LAYOUT OF BRIDGE NO. 7
ROSSVIEW ROAD
OVER WEST BOUND I-24
STA. 420+75.52
MONTGOMERY COUNTY
1972

DRAWING NO.	DESCRIPTION
BR. #4	K-99-110	LAYOUT
	K-99-111 THRU K-99-114	SUPERSTRUCTURE
	K-99-115 THRU K-99-116	BENT DETAILS
	K-99-117 THRU K-99-118	ABUTMENT DETAILS
BR. #5	K-99-120	LAYOUT
	K-99-121 THRU K-99-124	SUPERSTRUCTURE
	K-99-125 THRU K-99-126	BENT DETAILS
	K-99-127 THRU K-99-128	ABUTMENT DETAILS
	K-38-154A	BRIDGERAIL
	K-86-144	REINF. CONCRETE PAVEMENT AT BRIDGE ENDS

PROJECT NO.	YEAR	SHEET NO.
63001-4148-04	2002	11

NO.	DATE	BY	BRIEF DESCRIPTION
1	5-1-02	BE	ADDED BOXED NOTE & REVISED LIST OF DRAWINGS

ELEVATION

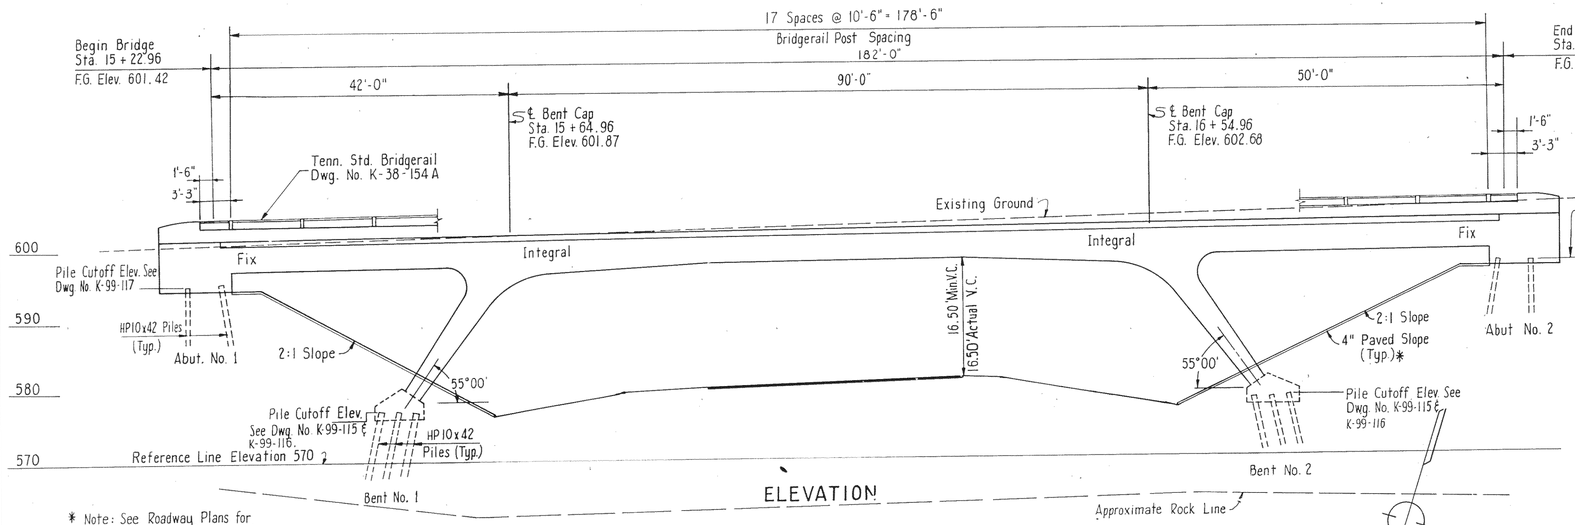
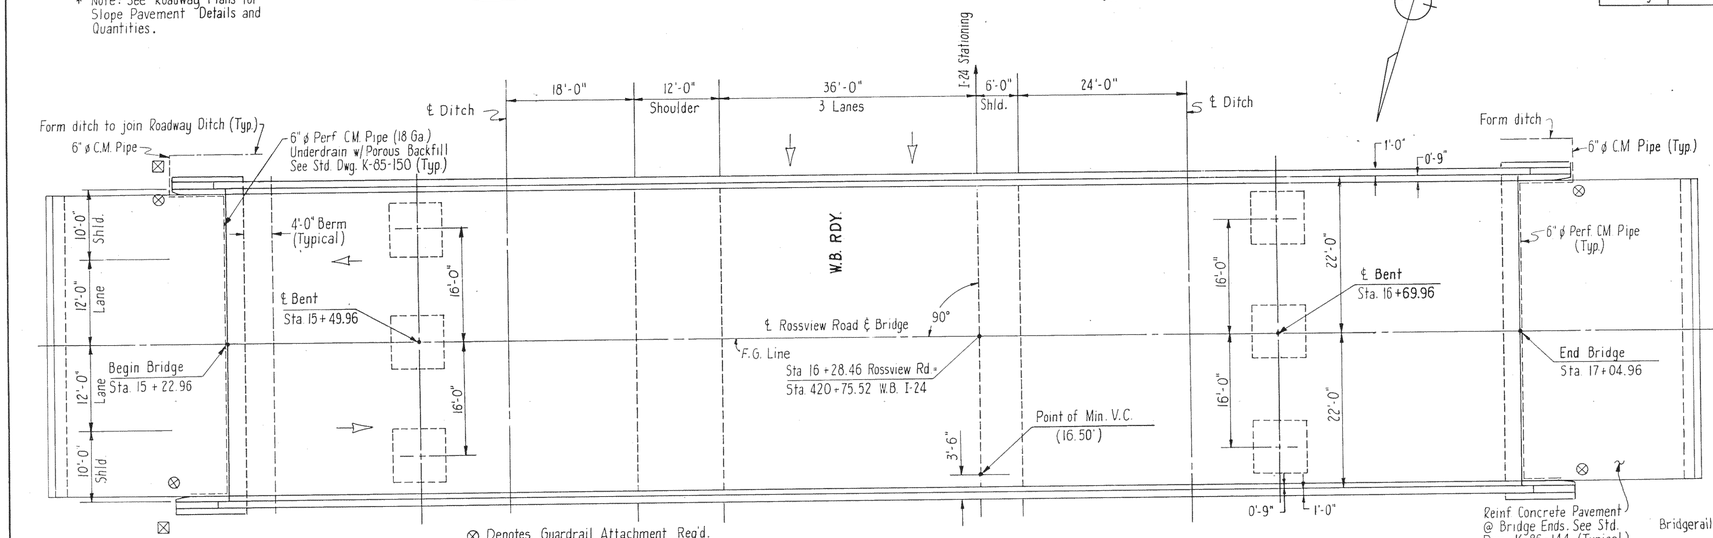
NO.	DATE	BY	BRIEF DESCRIPTION
1	11-4-74	M.V.C.	Dry Excavation @ Abuts. Added

PLAN

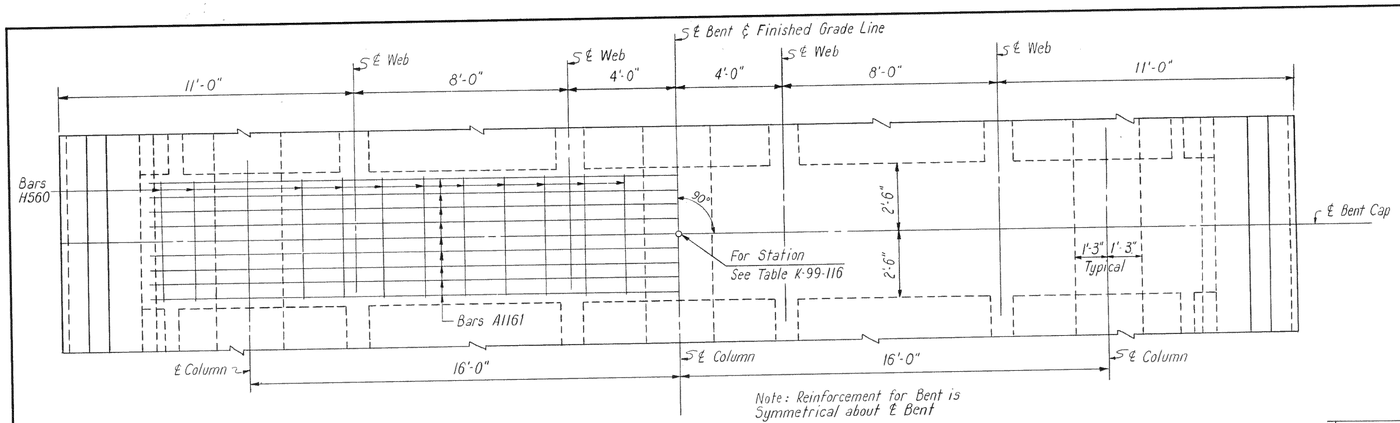
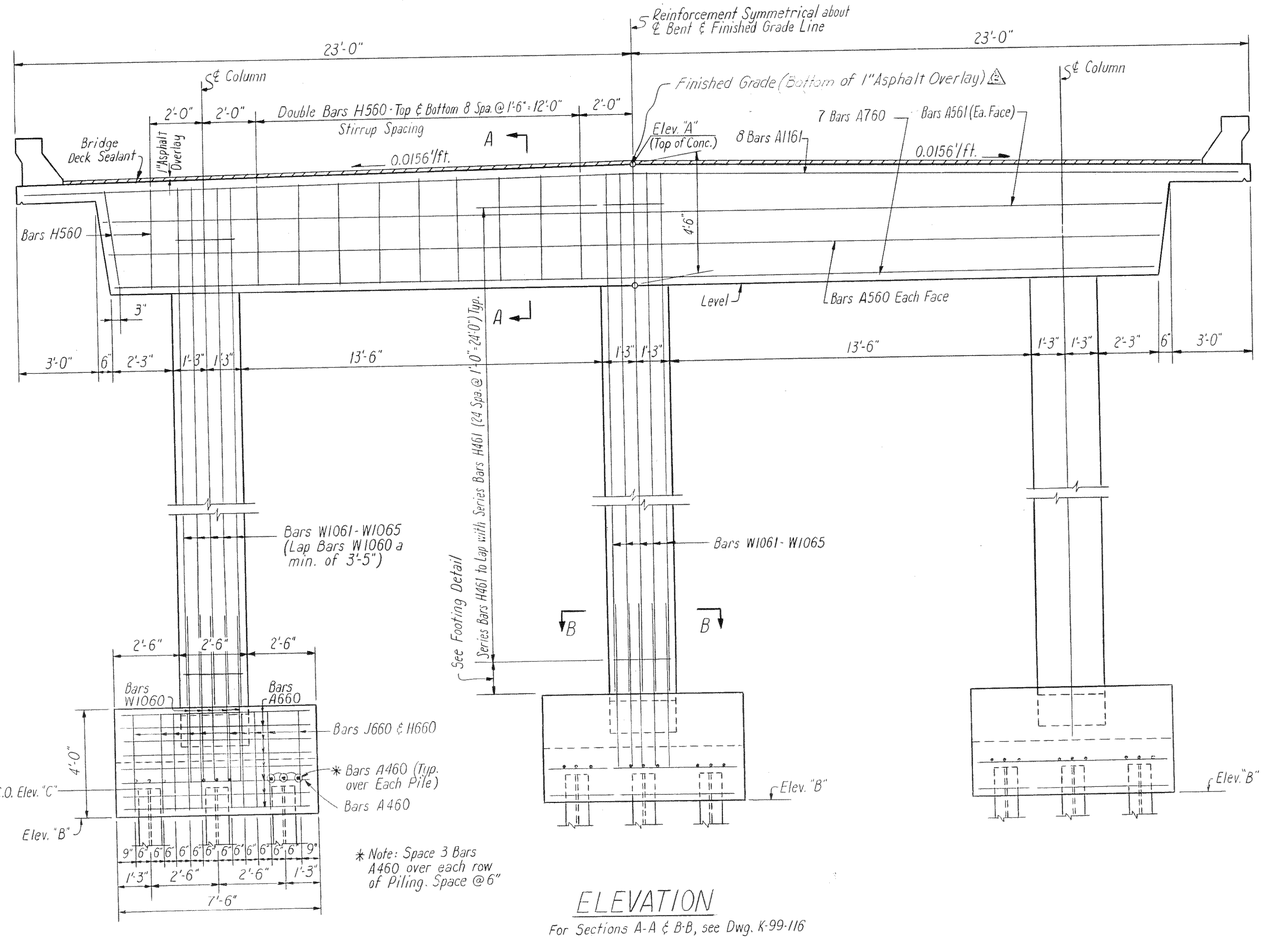
NO.	DATE	BY	BRIEF DESCRIPTION
1	11-10-72	H.M.B.	Bars A563 Changed To Bars X560
2	12-13-72	C.W.T.	REVISED LOCATION FIN. GRADE POINT

PLAN

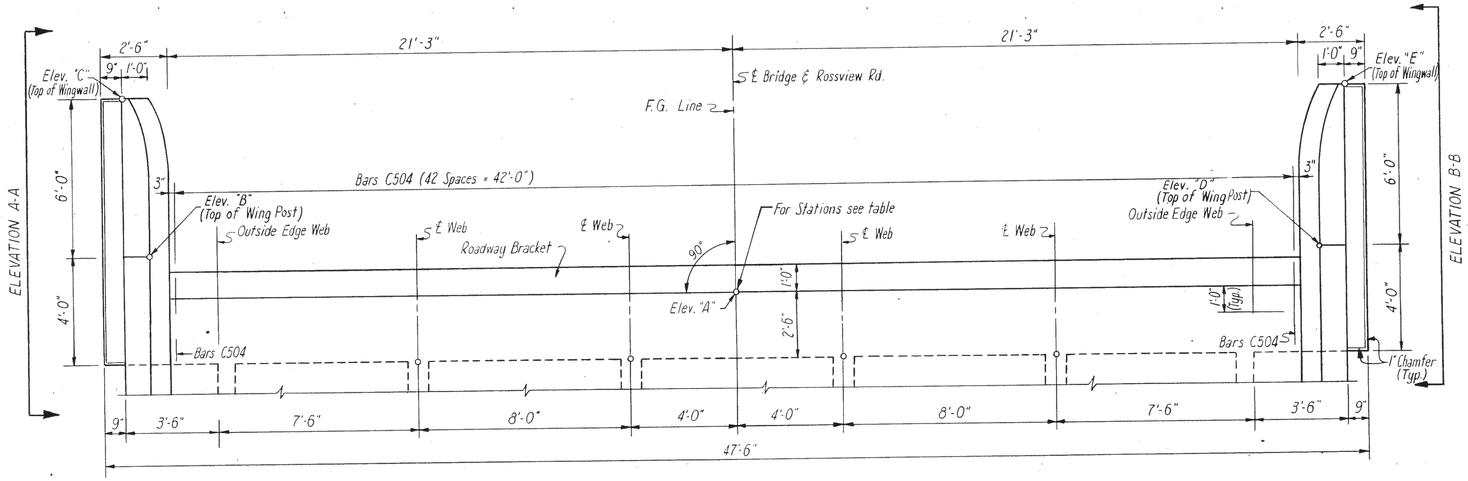
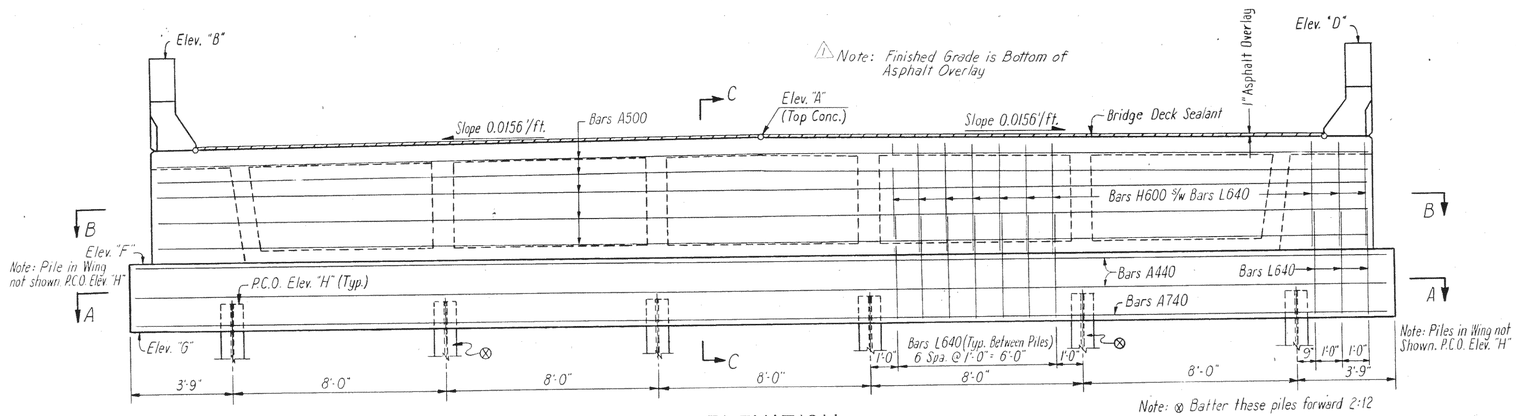
NO.	DATE	BY	BRIEF DESCRIPTION
1	12-14-72	CWT	Rev. Fin. Gr. Pr. & Table of Elev.

PLAN

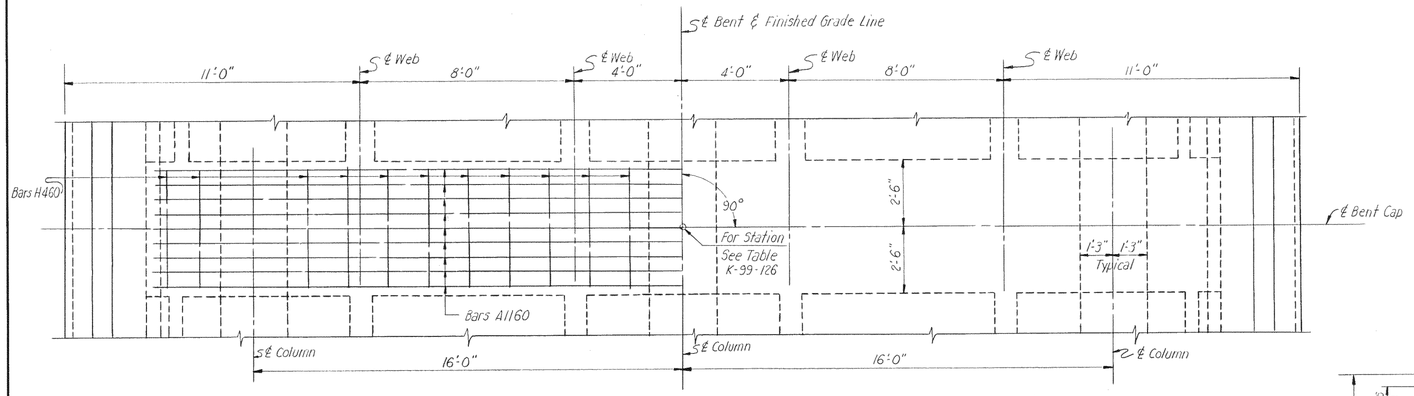
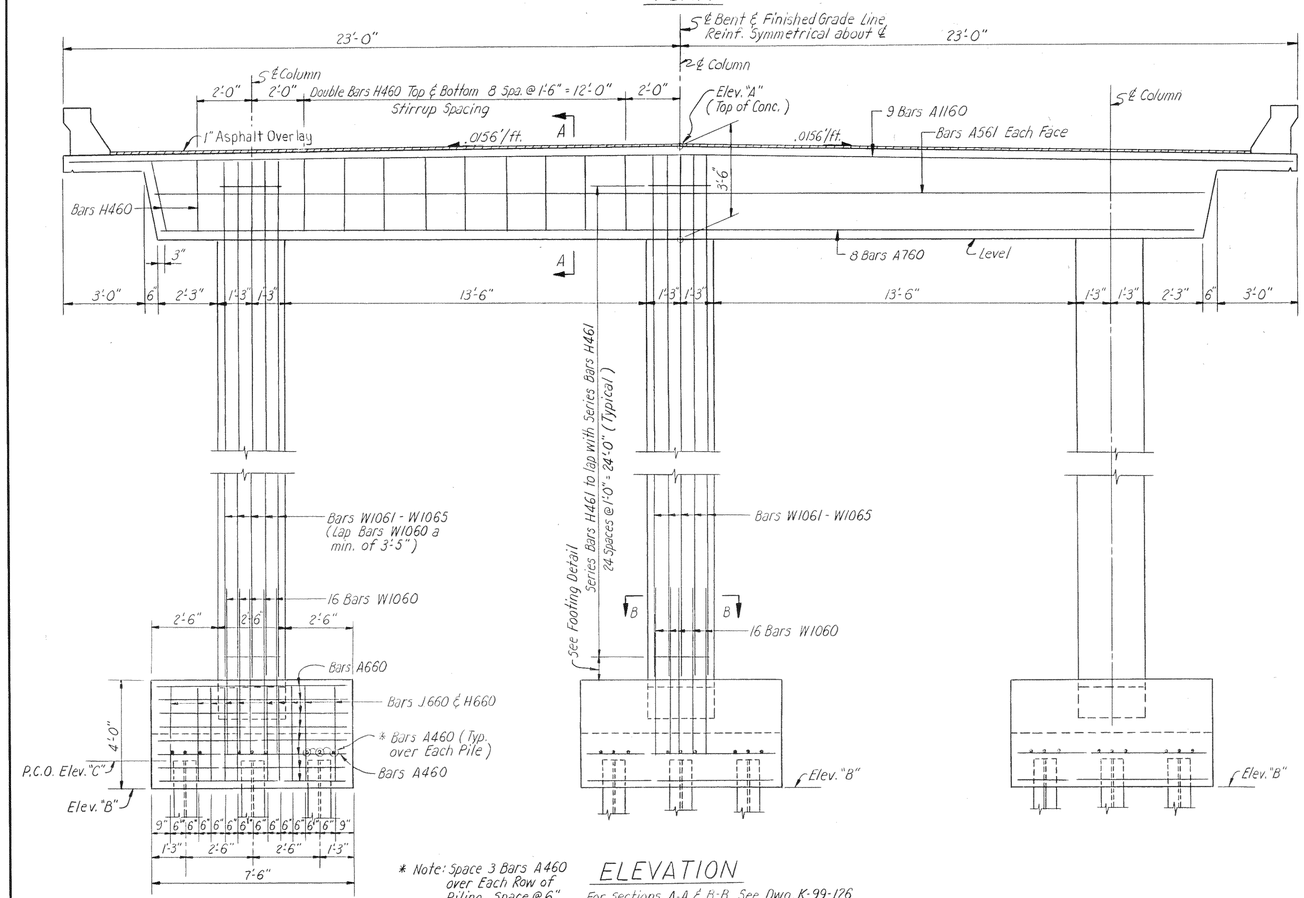
NO.	DATE	BY	BRIEF DESCRIPTION
1	11-10-72	HMB	Bars A563 To X560

PLAN

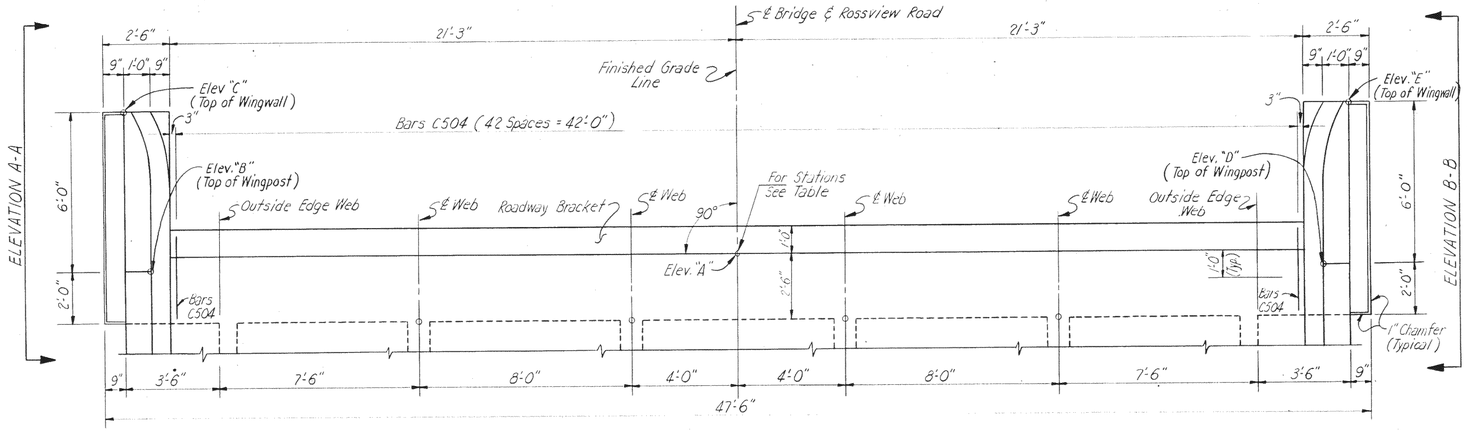
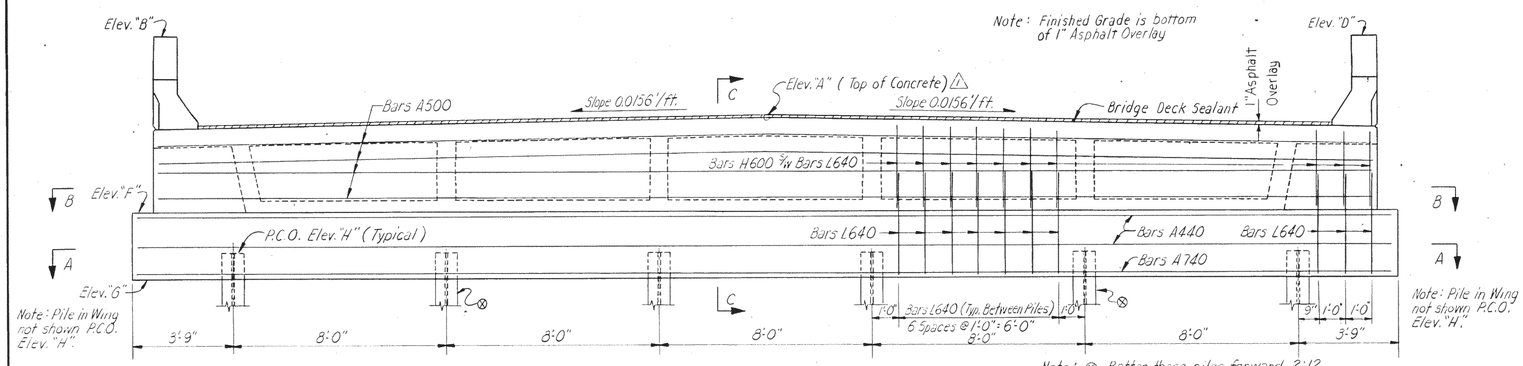
NO.	DATE	BY	BRIEF DESCRIPTION
1	12-14-72	C.W.T.	Rev. Fin. Grade & Table of Elevations

PLAN

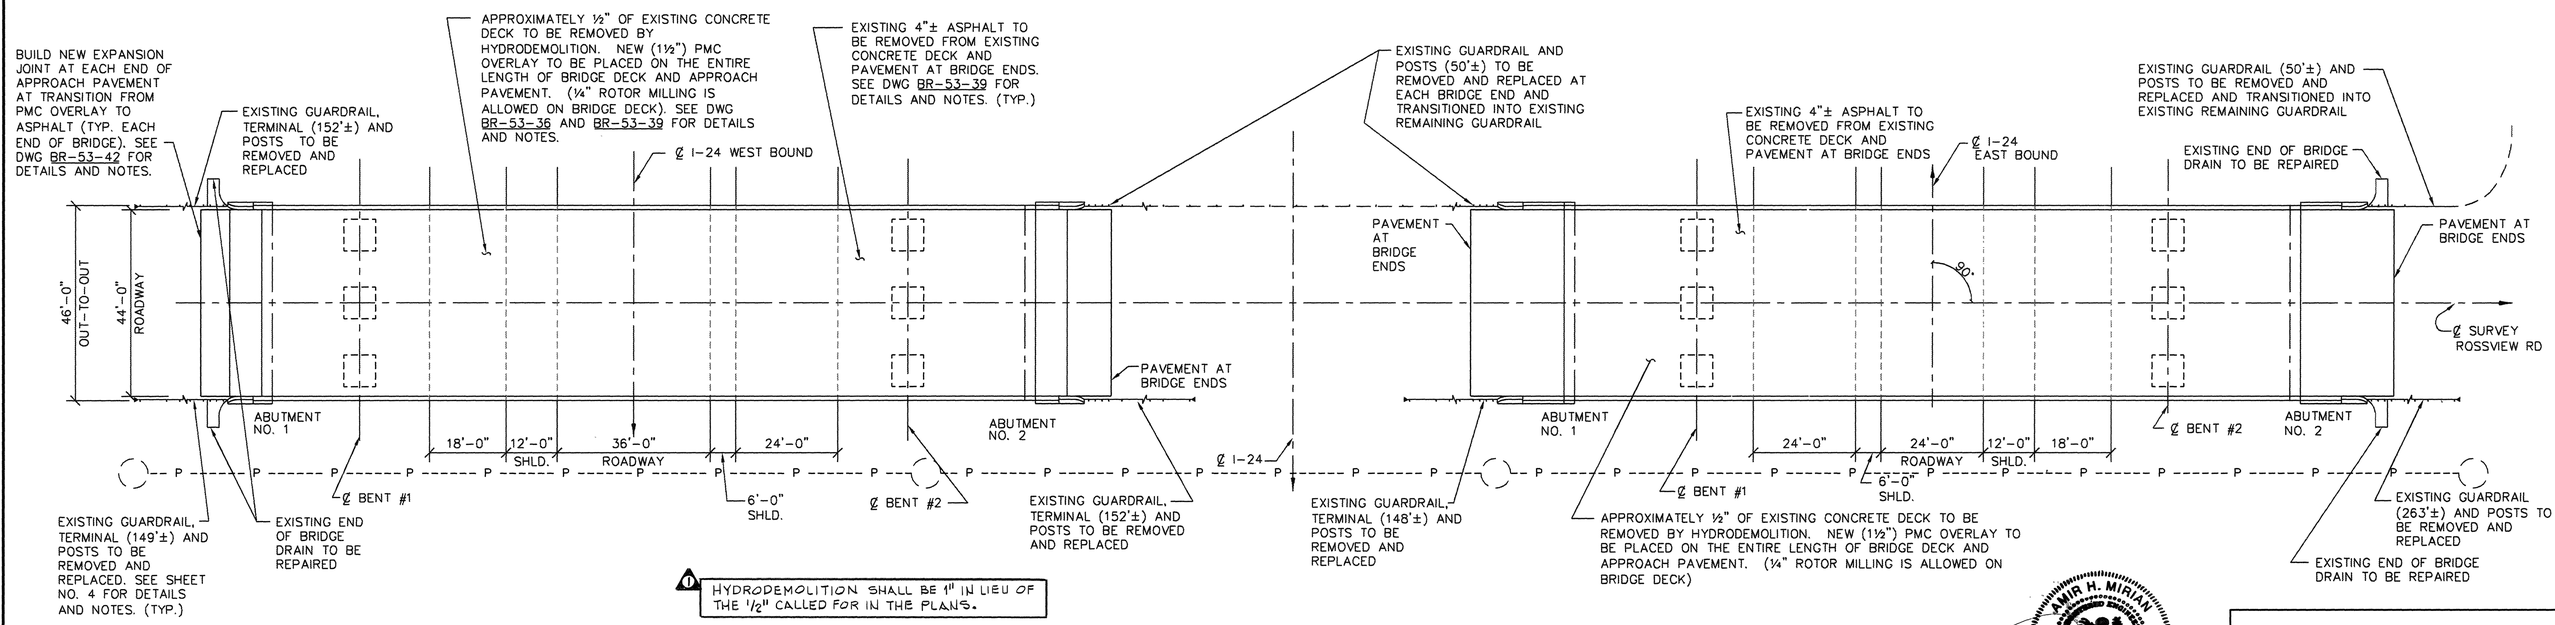
HYDRODEMOLITION SHALL BE 1" IN LIEU OF THE 1/2" CALLED FOR IN THE PLANS.
